Subject: Continuous Product Improvement - Introduction of More Robust Rocker Switch Assembly

Models Affected:

ECO#: A-6488

Figure 3:
Degraded contacts in
old switches 56265097
and 56265107

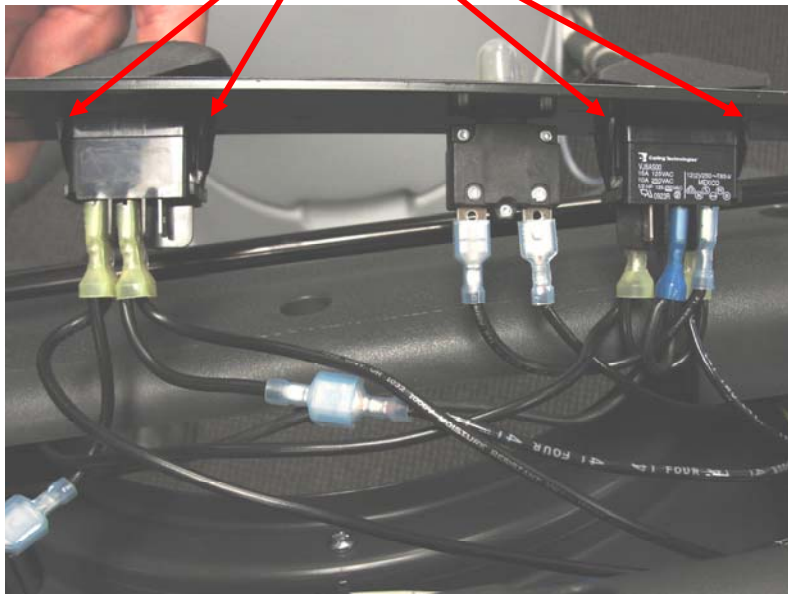
Issue: In some applications, premature rocker switch failure is causing the internal switch contacts to degrade quickly (Figure 3).

Cause: This premature failure is caused by the high in-rush current characteristics required for initial vacuum motor startup.

Effective March 31st, 2011 and beginning with serial number 4000015734, the switches that had been used previously were changed to a new and improved switch:

New switch 56381823 replaced switch 56265097

New switch 56381824 replaced switch 56265107
